CITY OF ALBUQUERQUE

RE: Advanced Auto Parts
San Mateo/Claremont
Grading and Drainage Plan
Engineers Stamp Date 8/7/15 (H17D111)

RE: H17-D111 – Advance Auto Parts, San Mateo and Claremont: Drainage and Hydrology Review Comments Response

Grading & Drainage Plan (H17D111)

RETENTION POND & OUTFALL DETAIL SCALE 1" = 10'

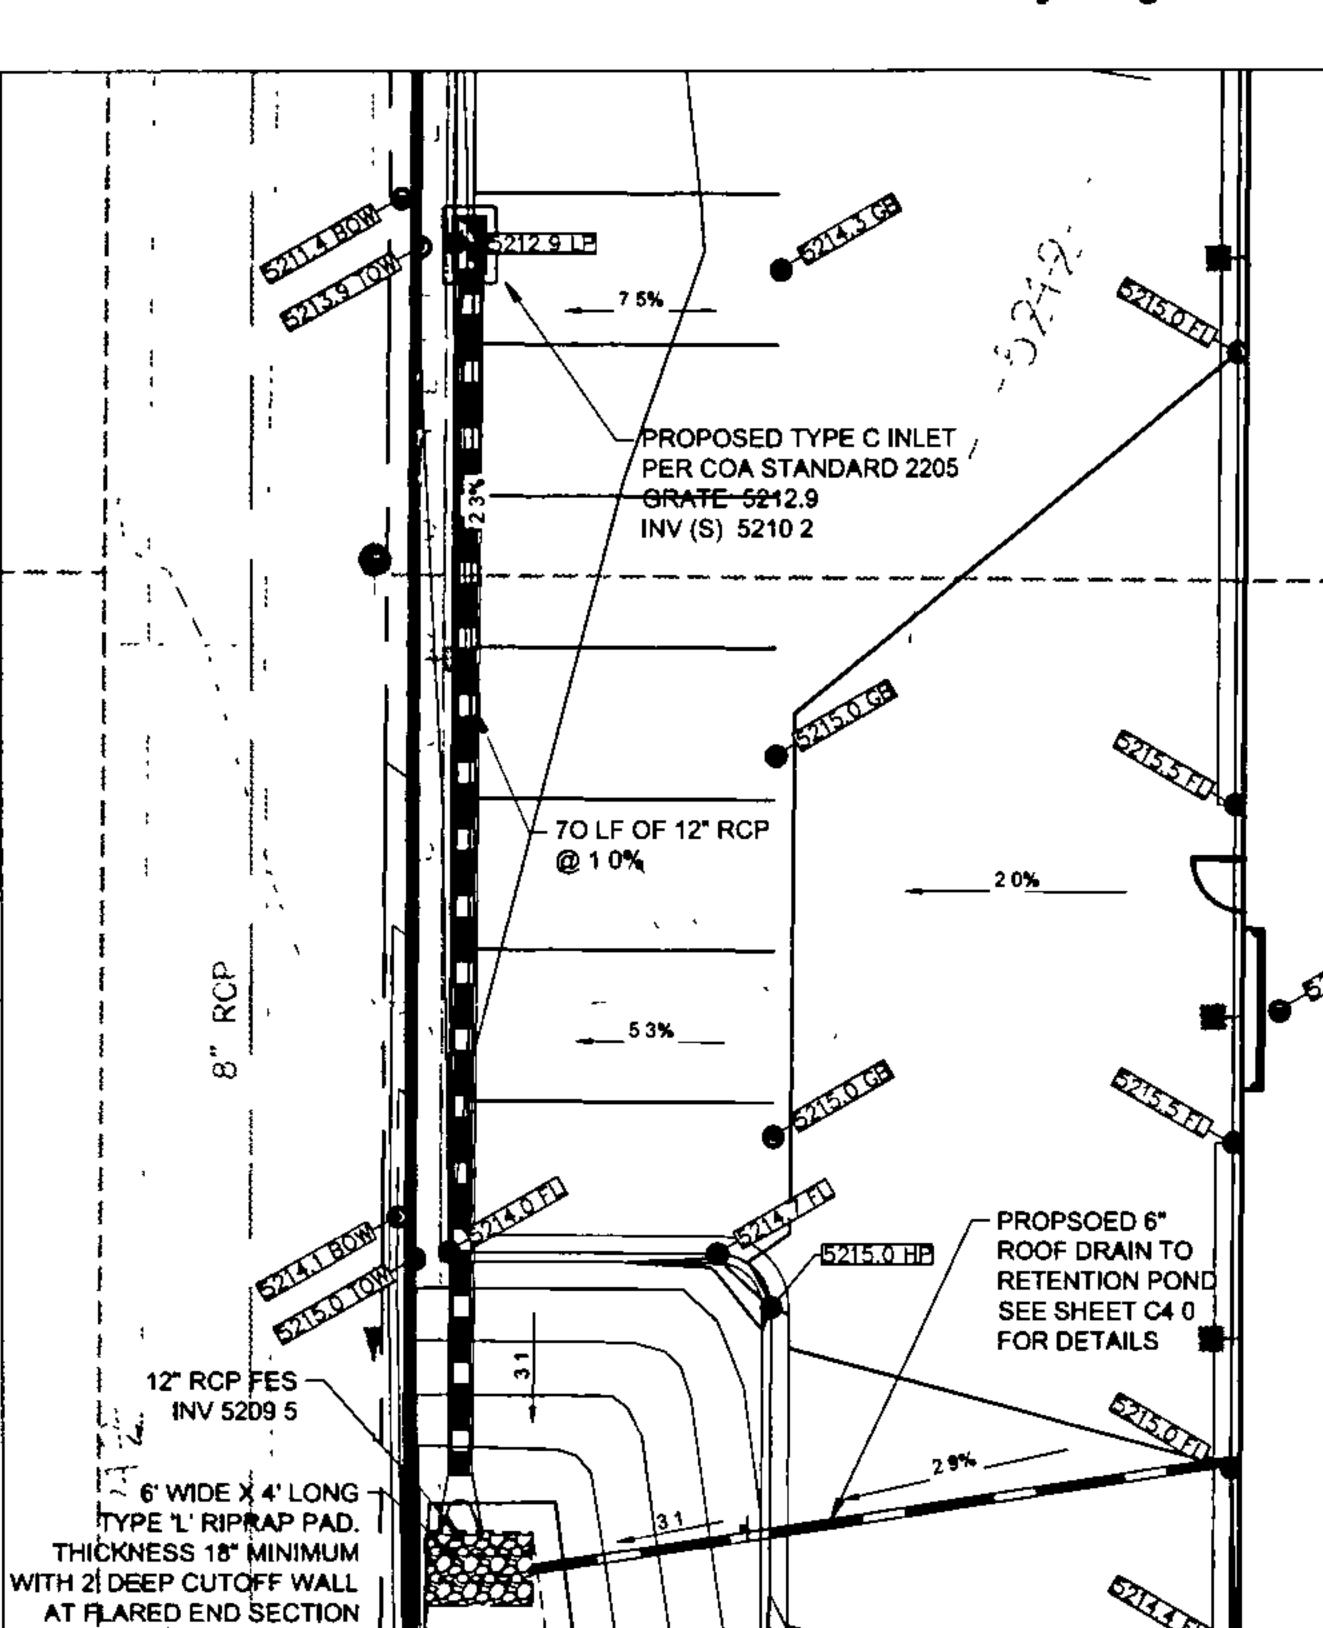
2. Provide an invert for the pipe in the pond.

- 7. An emergency overflow is needed for the pond. Direct the emergency overflow for the pond toward the drive pad in Claremont.
- 8. RESPONSE: As part of the drainage re-design a formalized outfall structure to Claremont has been added. This includes a concrete channel and sidewalk culvert. This has been sized to accommodate the 100-year flood event.
- 9. Provide a Floodplain Permit for this site. Also, before CO is given for this site a LOMR-F must be completed and an elevation certificate provided.

RESPONSE: As part of the drainage re-design the existing outfall pipe has been removed. The new design has a pipe that discharges into the pond and overflow outfall structure. Invert elevations have been included for the new pipe and outfall structure.
